### Interim Review of 110 Kiwi Rd Flooding

Ian Holyoake. 23 November 2023

This report is focusing on flooding at 110 Kiwi Rd. Thee problem and some solutions. It is an interim report because I am waiting on LGOIMA responses, responses to the Kiwi Rd petition, response to the letter to the Mayor and our stakeholders workshop debate.

105 20231119.jpg

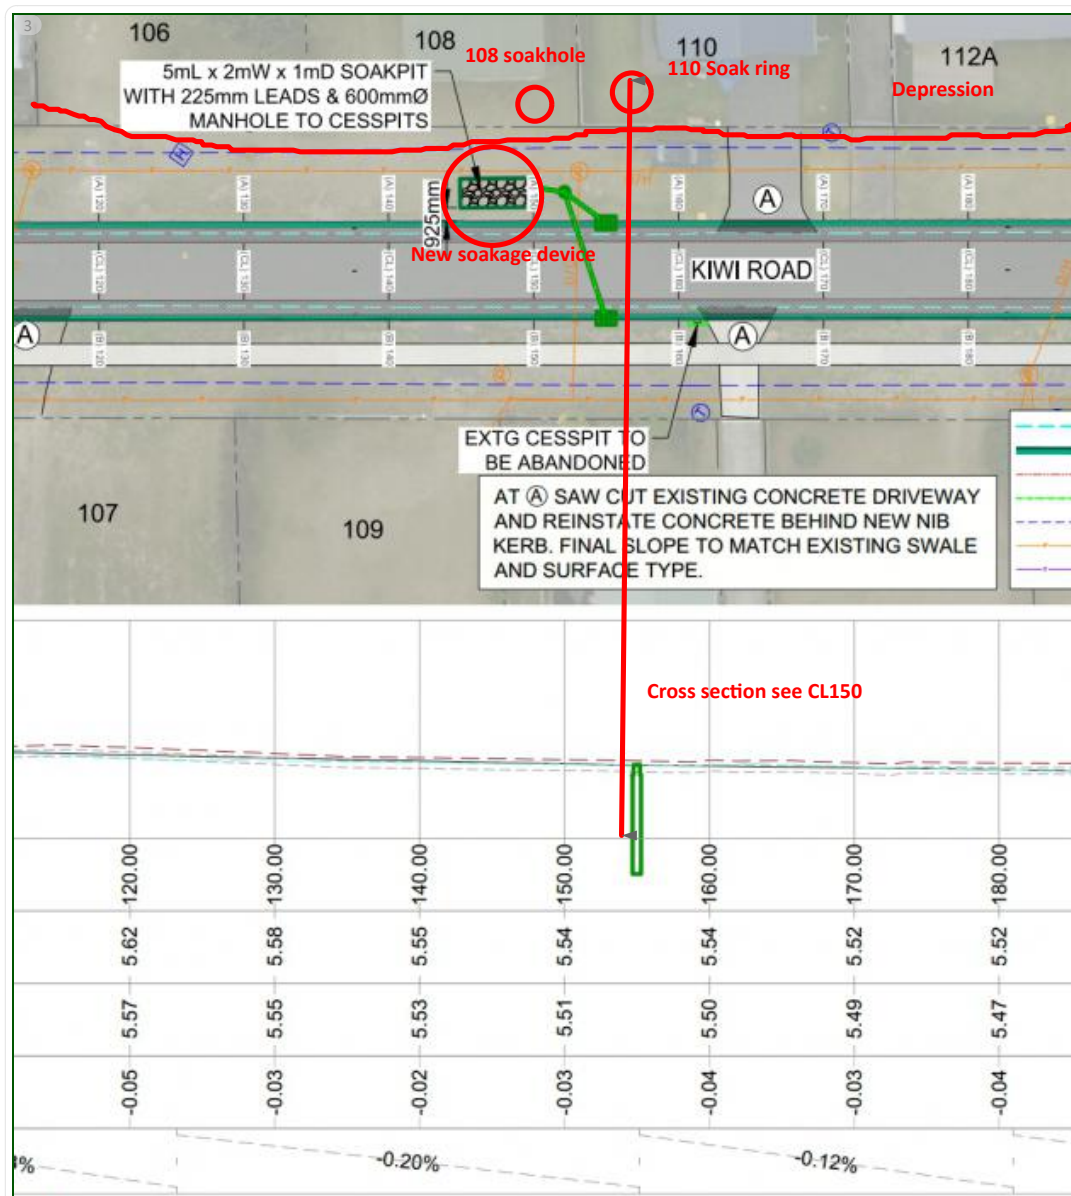
Cesspit opposite 108 and 110 Kiwi Rd overwhelmed on 19 November 2023 then flows to the Kea Street cesspit. Some of the water originates from Tui Rd. The Kea Street soakage devices were immediately overwhelmed which causes stormwater to back up, rise and trespass.

Noted the other side of the road kerb and channel was not as full with water as the crown at this stage is preventing water breaching across.

The cesspit outside 108 Kiwi Rd was full - this will be because of the pipe connection from the flooded cesspit.

No solution will be found for Kiwi without dealing with Tui and repositioning the soakage device away from low lying land.

200 Plan at 110 Kiwi Rd.jpg

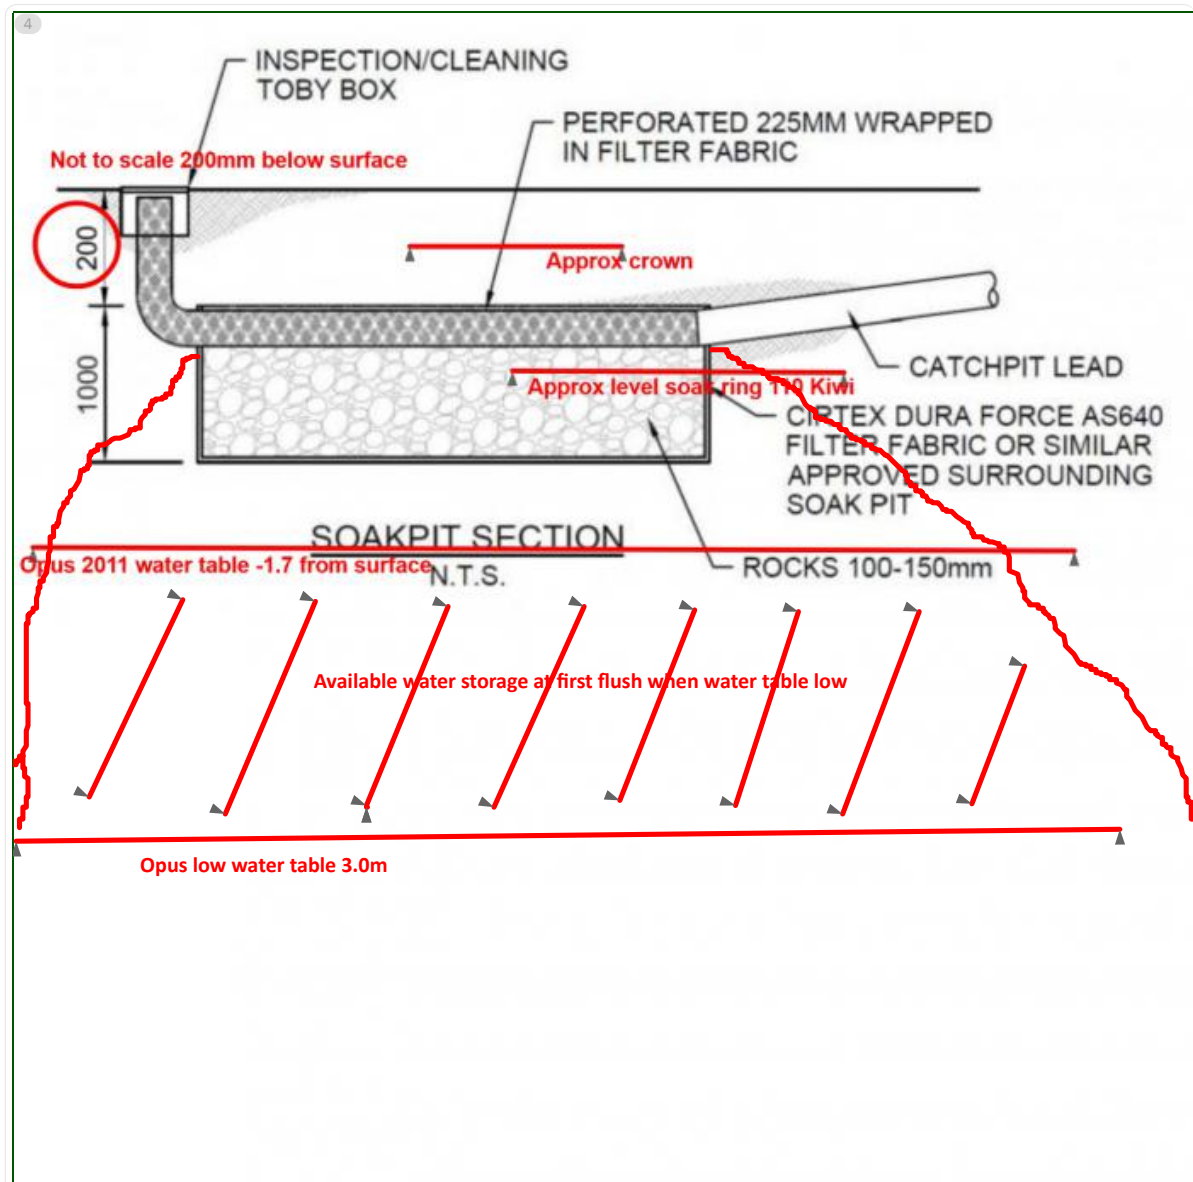
Pinnacle Plan detail at 110 Kiwi Rd between CL140 and CL150

Soakpit is in front of 108 Kiwi Rd

Plan does not have LIDAR contours - freehand line is approx edge of depression - noted 110 Kiwi Rd is below 108 Kiwi Rd.

There was an existing cesspit on opposite side of road which was abandoned. This will be the original low ground.

Looking at levels it seems the ground is pretty level making drainage to single points means water becomes deep and can breach the nib kerb and flood properties enroute to the soakage device.

Rings denote soakage devices at 108 Kiwi Rd and 110 Kiwi Rd

Cirtex circled and green box denotes new road soakage device outside 108 Kiwi Rd

No inspection hatch for maintenance found

No reason why Kiwi Rd soakage device was constructed at this particular location.

20231120\_213743\_SC\_.jpg

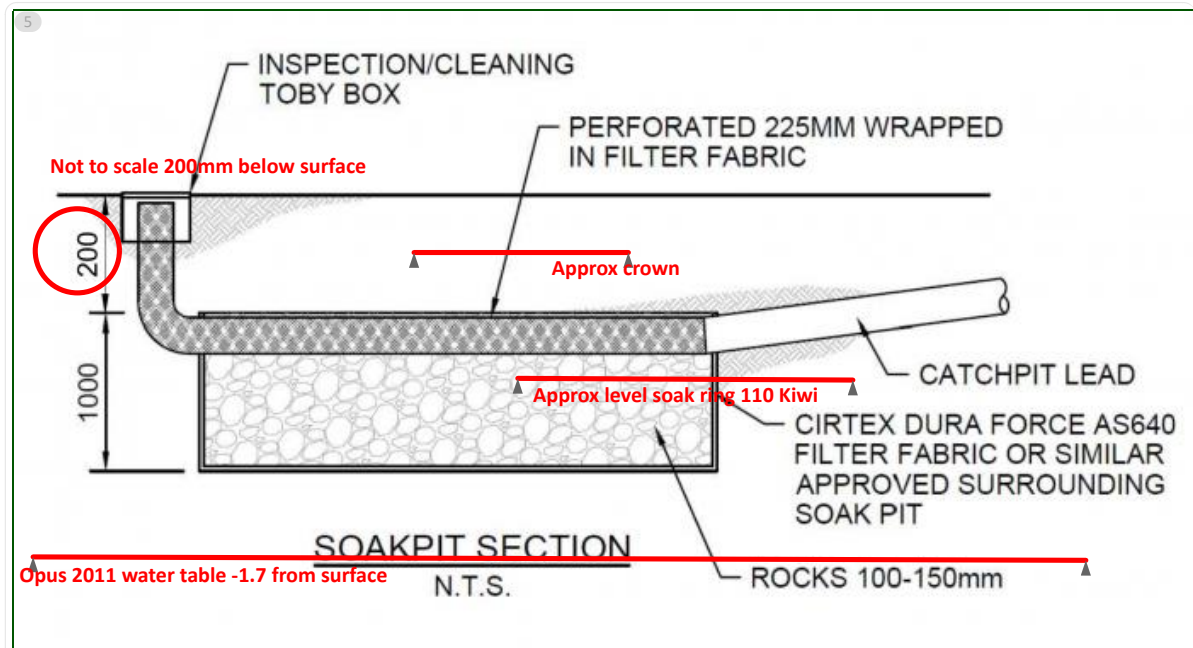
On the lead up to Hale we had a dry end of year so the water table could have been 3.0M below the surface (Opus Bore 3).

At Cyclone Hale first flush the area below the soakage device was capable of storing surface water entering the system. Denoted by area below the soakage device.

As the rain persisted the water table would rise - eg to Opus 1.7M below the surface.

At cyclone Gabrielle the next first flush only has the area above the 1.7M line available for storing surface water.

Whilst lateral filtration/absorption will be occurring, together with hydraulic pressure from the weight of the saturated sand, the water table will crest up below the soakage device.

The top of the Kiwi Rd soakage device is about 300mm above the ground level of 110 Kiwi Rd.

'Breakout' will then occur through the sloping ground onto the surface of the depression within 110 Kiwi Rd.

What compounds the issue is as the soakage devices becomes overwhelmed the stormwater collects as surface water which then drain backs into the cesspit and feeds the breakout onto 110

220 Soakage pit Kiwi Rd at CL 150.jpg

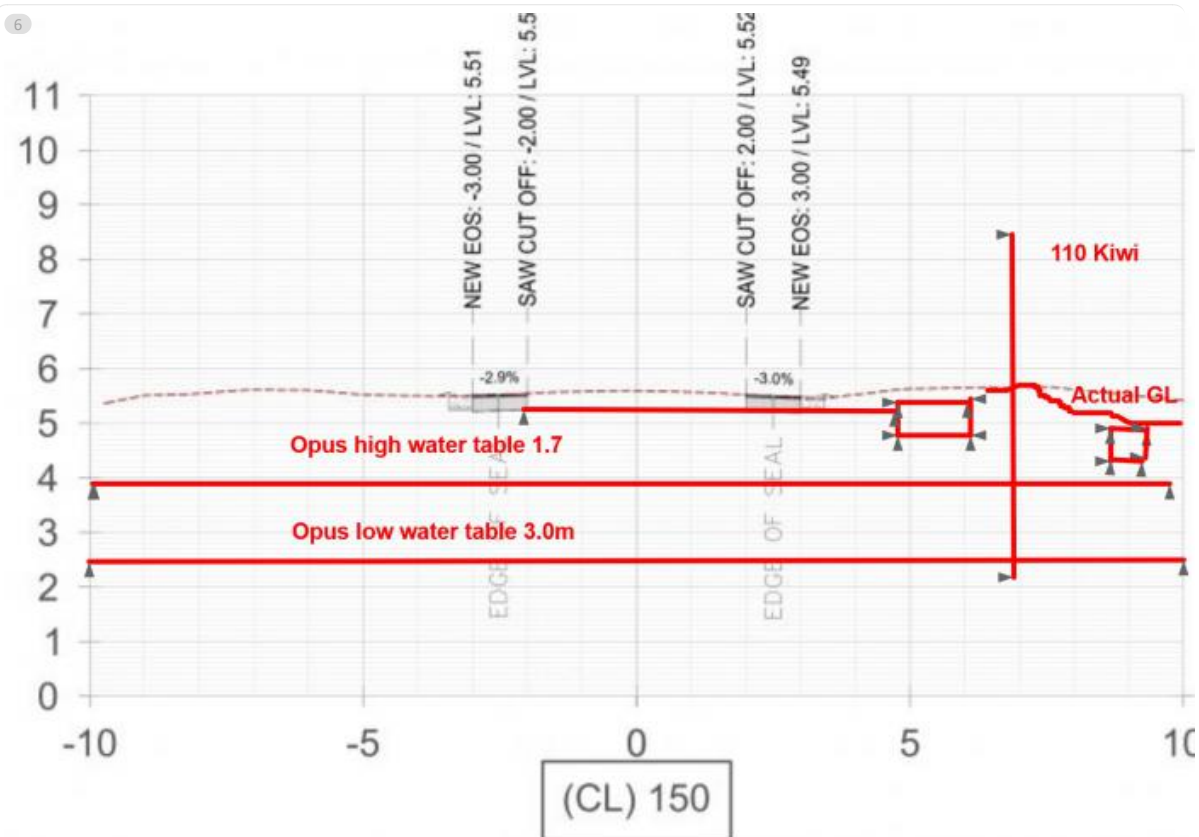
Note shows top of soakpit to be 200mm below ground level - states not to scale as 1000mm deep is out of proportion to the 200mm

Note shows rocks 100-150mm. We believe this is incorrect and substituted to Cirtex plastic crates.

We found a second cesspit along the catchpit lead but not yet found the inspection/cleaning toby box.

The horizontal line is presumably the grass verge line which is higher than the curb and channel.

The top red line is about the line (to scale of the 200mm) which is above the grate height of the catchpit

The lower red line is the approximate ground level of 110 Kiwi Rd which means the soakage device stores water to above the level of the depression on 110 Kiwi Rd.

I do not have LVL for the site as the new stormwater assets are not loaded into SmartMaps. For the discussion I am using Opus BH03 Groundwater data and taking it for now that BH03 in relation to Achilles crown is the same level as the Kiwi Rd to crown.

The Opus report 2011 the minimum ground water clearance (ie height of water table) was 1.7m - note the maximum length and volume of rains during the study is less than half Hale/Gabrielle and subsequent repeated events. It is conjecture but if the road soakage device base is 1.2M down it would be 500mm above the 2011 water table. It is not.

That leaves 500mm of sand to store flood water below the soakage device. This is not enough.

240 Cross section showing water tables and soakage devices.jpg

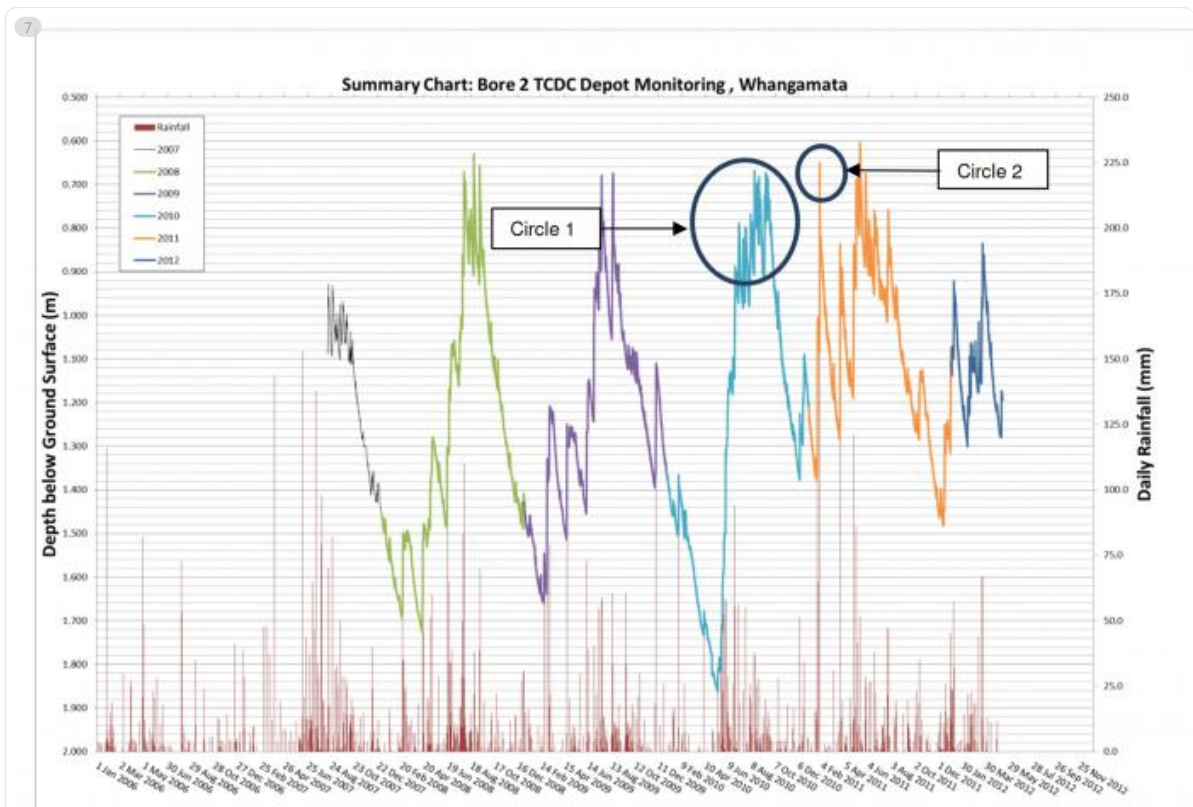
The road soakage pit design does not meet the TCDC soakage pit design requirements of 500mm above winter water table levels.

Neither does 108 or 110 Kiwi Rd meet this criteria.

There are no soakage test results for any of these 3 soakage devices.

The dotted grey line is NOT correct. The dotted grey line does not follow the actual ground contour of the low lying land along Kiwi Rd starting at 100 Kiwi Rd (and back to Achilles) right down to about 118 Kiwi Rd.

What was viewed on 19 November 2023 is rainwater is marshaled along the nib/channel and into the cesspits as shown. The rainwater almost immediately overwhelmed the soakage device at 108 Kiwi Rd, the rainwater level rises until it banks up back to Achilles and along to the cesspit at Kea St. It took about 10 mins to then overwhelm the Kea St soakage devices. Then water banks up and overflows into the low lying properties along Kiwi Rd.

600 CL 140 Kiwi Rd.jpg

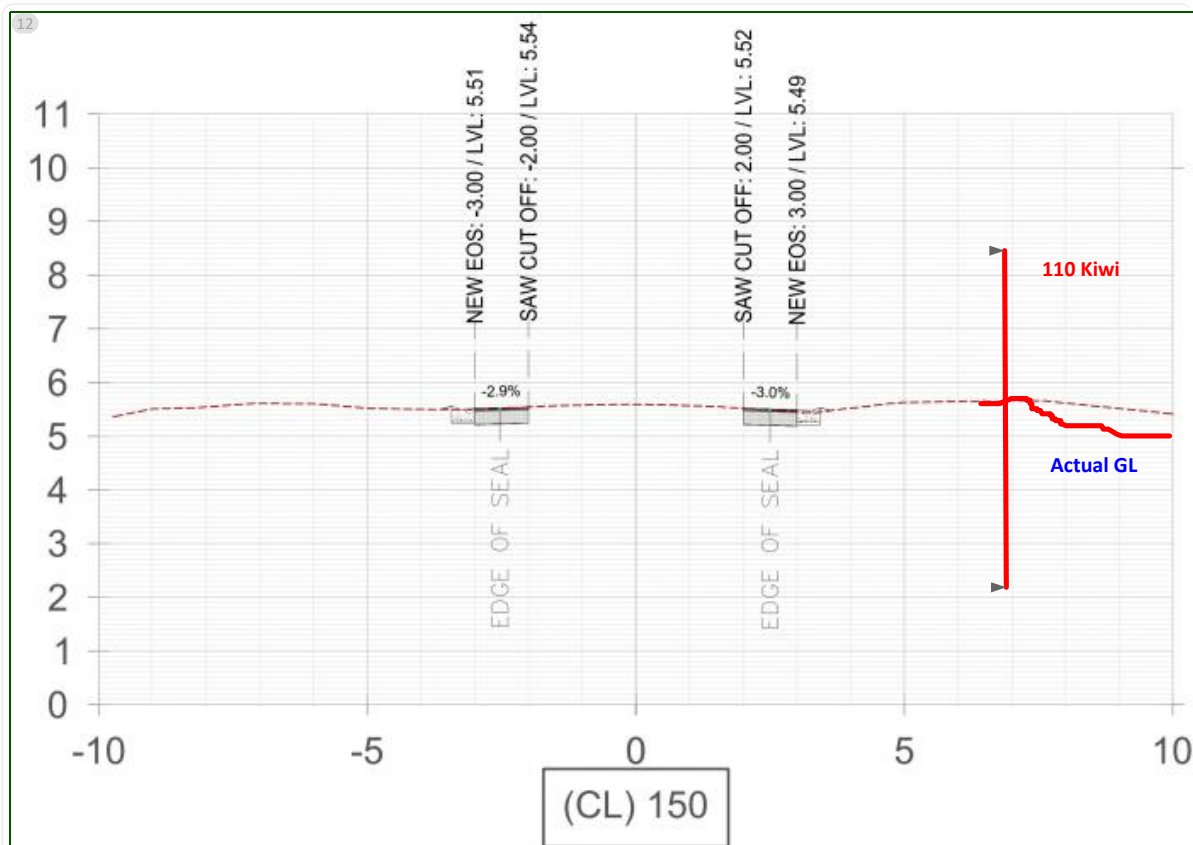
Cross section of purported ground line to LVL at CL 140 which is at 108 Kiwi Rd far edge of soakpit.

Note LVL varies 5.53 to 5.55M ie 200mm with the dotted line not falling below the edge of seal and new EOS

Portions of 108 Kiwi Rd property is below the road crown. This cross section is not correct.

610 CL 150 Kiwi Rd.jpg

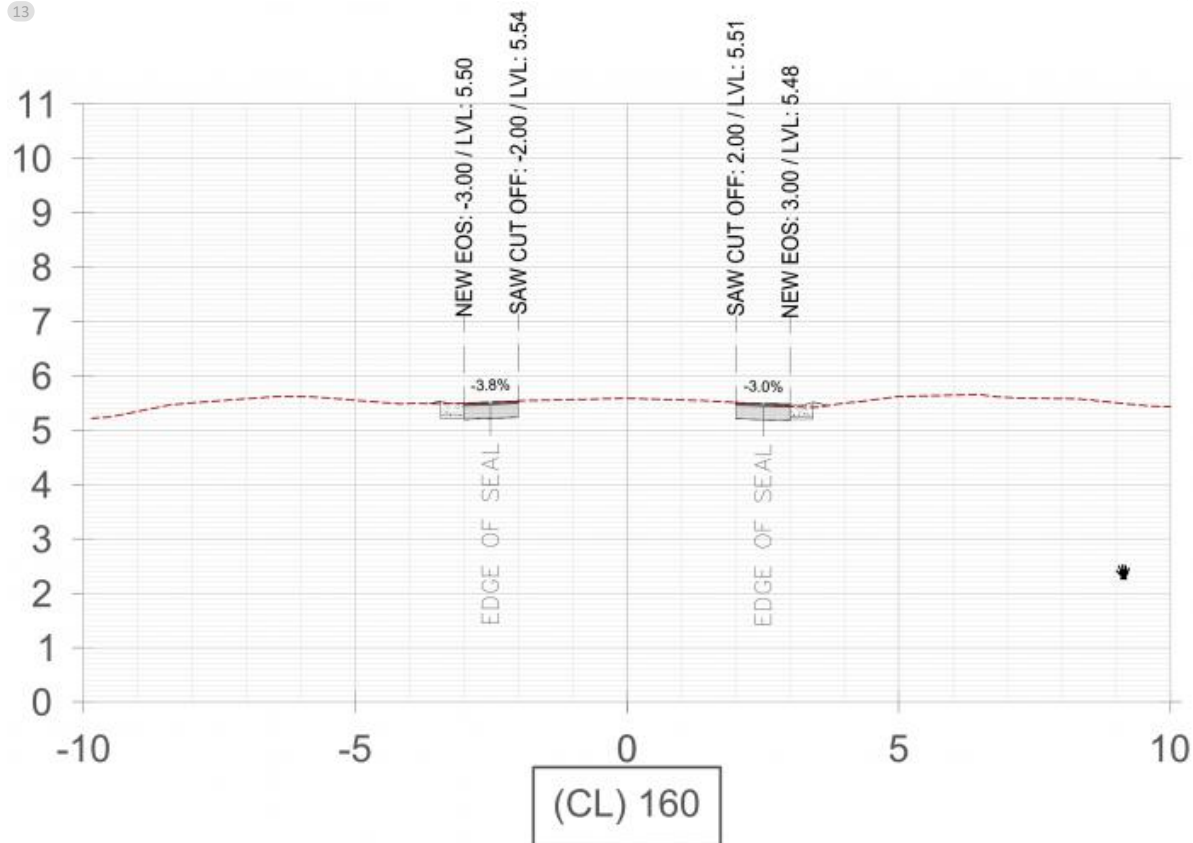
Cross section ground level at CL 150 to right of soakpit and near boundary between 108 and 110 Kiwi Rd.

LVL now 5.51 to 5.54M with low point around 100mm at -10M left and dropping - on both sides.

ie at edge of roadage boundary the top of the soakpit at -200mm below ground - but probably only -100 below the top of the cesspit grate - is still below the road boundary by about 100mm.

The actual ground level in 110 Kiwi Rd is much lower than the cross section shows.

My measurements by eye suggest it is -300mm from the top of the road soakage device

Using BH03 the 2011 water table could be this horizontal line.

The box is the new road soakage device

The storage below that to the water table is minimal to the 2011 peak water table which was only 746mm of rain compared to this period >1.6M

This would mean the water table rose to above the actual GL of 110 Kiwi Rd

BUT the fact it did will be because of lateral absorption from the road soakage device. As the water table rises the soakage device does not work so water breaks out through into the depression.

620 CL 160 Kiwi Rd.jpg

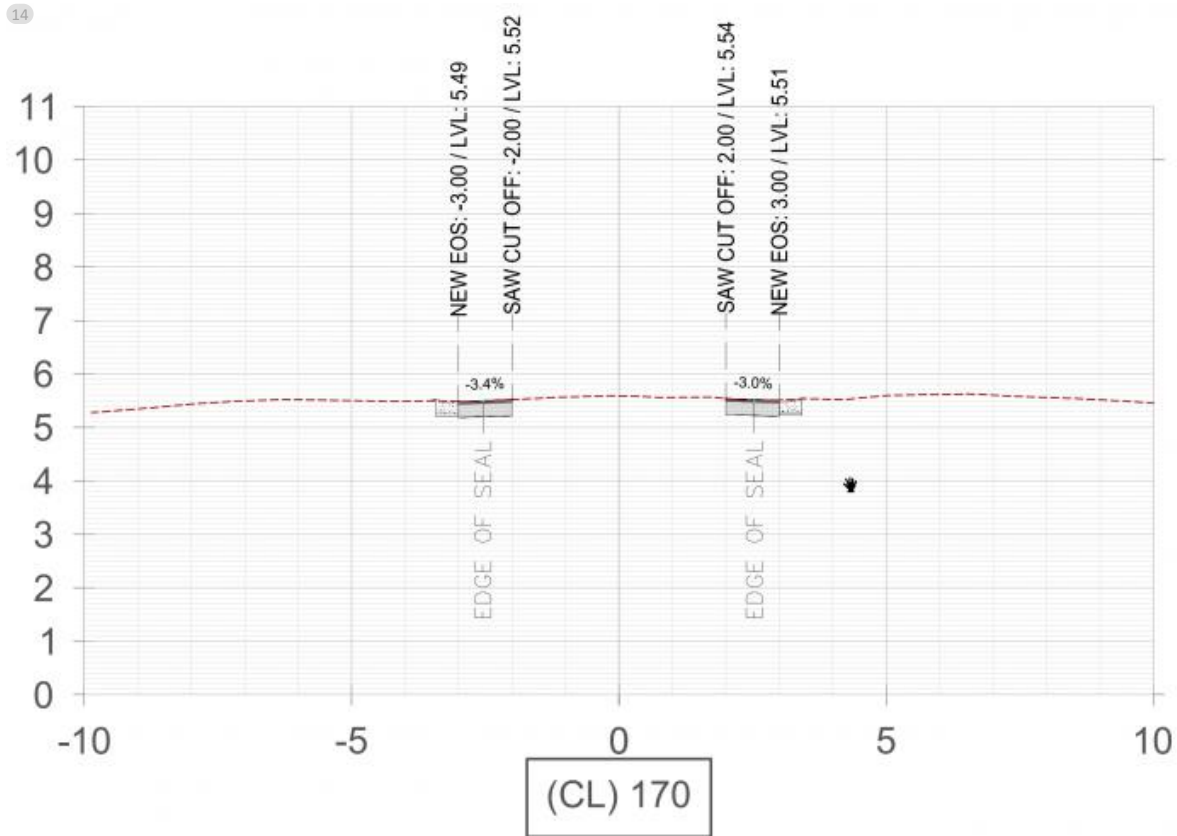
Cross section at CL 160 beside driveway into 110 Kiwi Rd.

LVL now 5.48 to 5.54M

Ground height to left now drops to 5.2M ie now at -100mm below top of soakpits.

Noted 110 Kiwi has a depression basin at about -500 to -600mm below crown of road.

This would mean ground level inside 110 Kiwi Rd is 300-400mm below the top of the soakpit

The road EOS was overloaded which means the soakpit is full (-200mm) so water soakage into the sand is cresting and flowing through the sand verge and draining into the basin 300-400mm below.

This is likely to mean the overall Whangamata water table may not be the influencer of surface water within 110 Kiwi Rd - because the source is the cresting flow coming from the soakpit which is loaded to +400mm above the basin so drains in.
